AGENDA

CITY OF OPELIKA HISTORIC PRESERVATION COMMISSION

March 10, 2022

Agenda Item #: 1
Meeting Date: 03/10/2022
Action Requested: COA: Install Wood Privacy Fence
Location of Property: 408 S. 8th St; Geneva Historic District
Petitioner: Wendy Bonner & Aaron Bushey

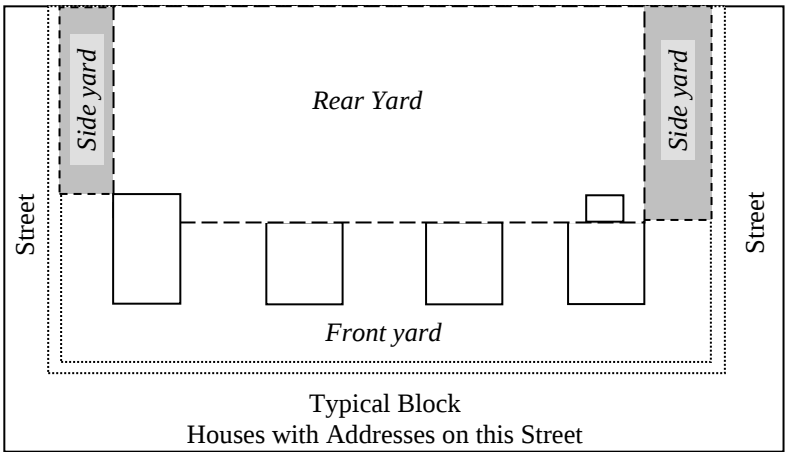
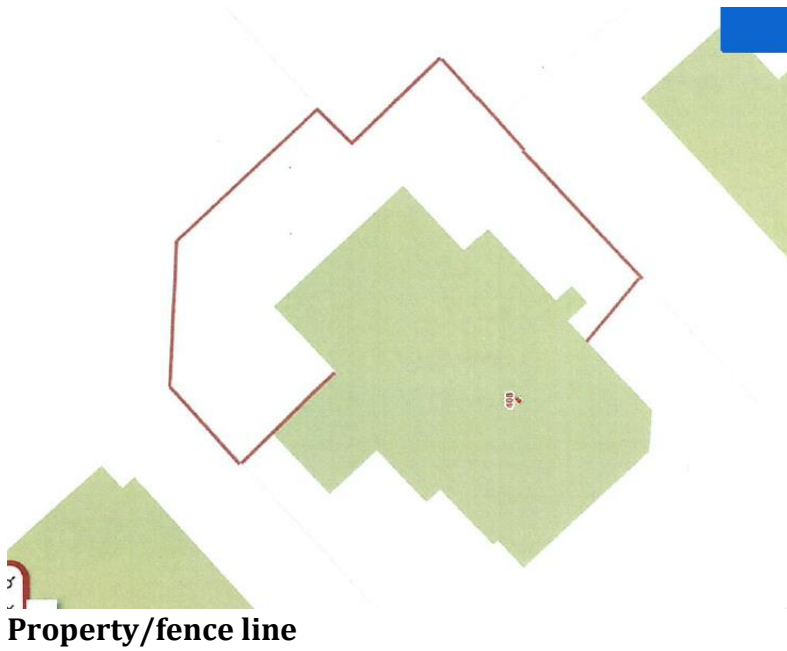
- 1. Install 8 ft. cedar or pine privacy fence around perimeter of yard. Replace the gates on the left and right sides of the house with the same size as they are currently. The North and East sides of the yard are adjacent to a commercial parking lot.

1. Staff recommends approval of cedar or pine privacy fence meeting all required guidelines.

Agenda Item #: 3
Meeting Date: 03/10/2022
Action Requested: COA: Repair Wall and Mortar Wash
Location of Property: 223 S. 9th St; Downtown Historic District
Petitioner: Barrett-Simpson, Inc.

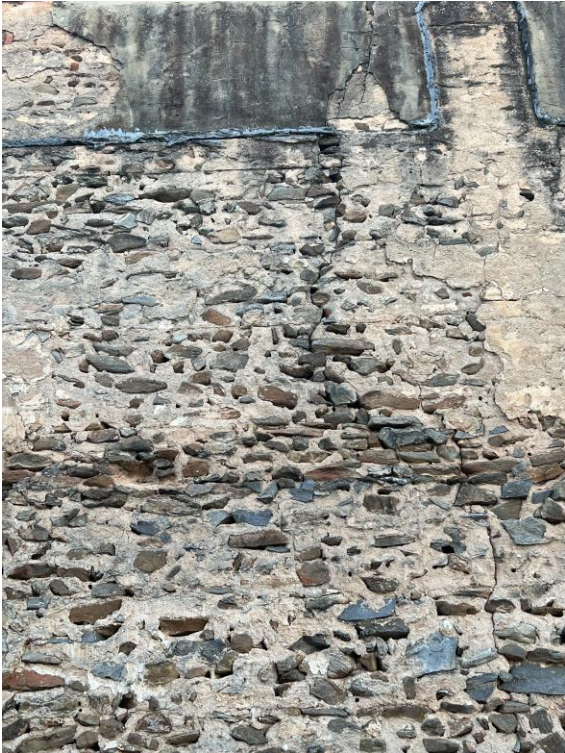
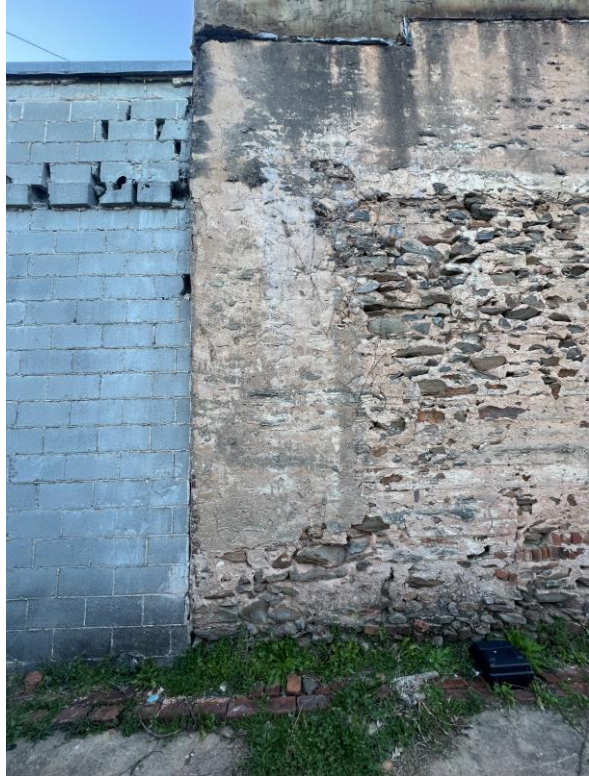
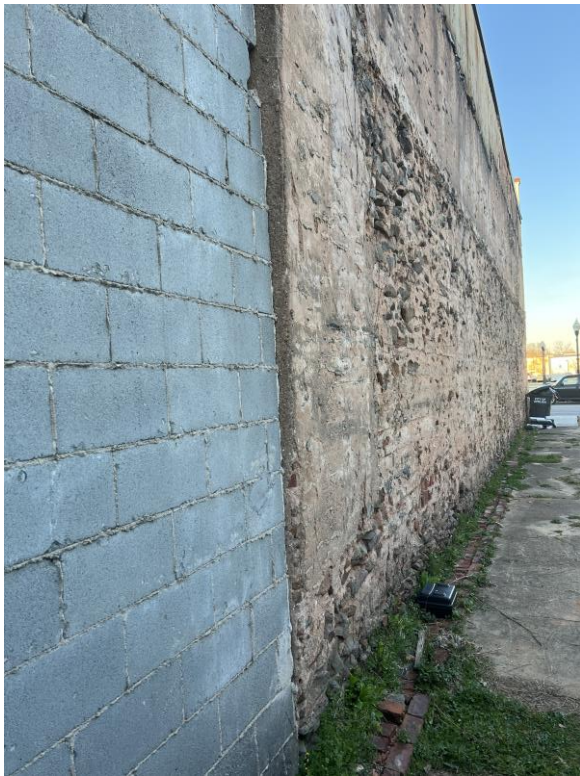
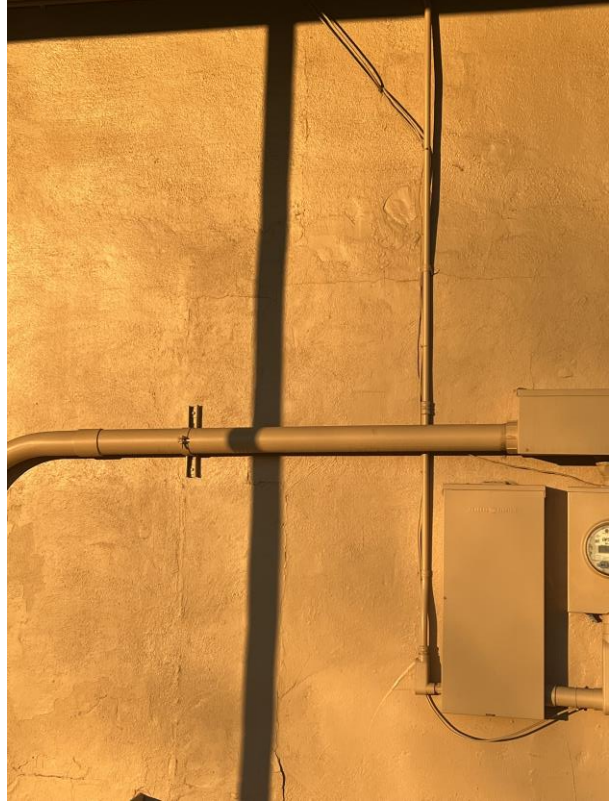
1. Repair crumbling southern rock wall by grouting all crevices and applying a mortar wash.

History: A Certificate of Appropriateness was approved on 01/13/2022 for mortar repair of wall only but no mortar wash. Applicants wishes to discuss options further with commission.

No Staff recommendation required.
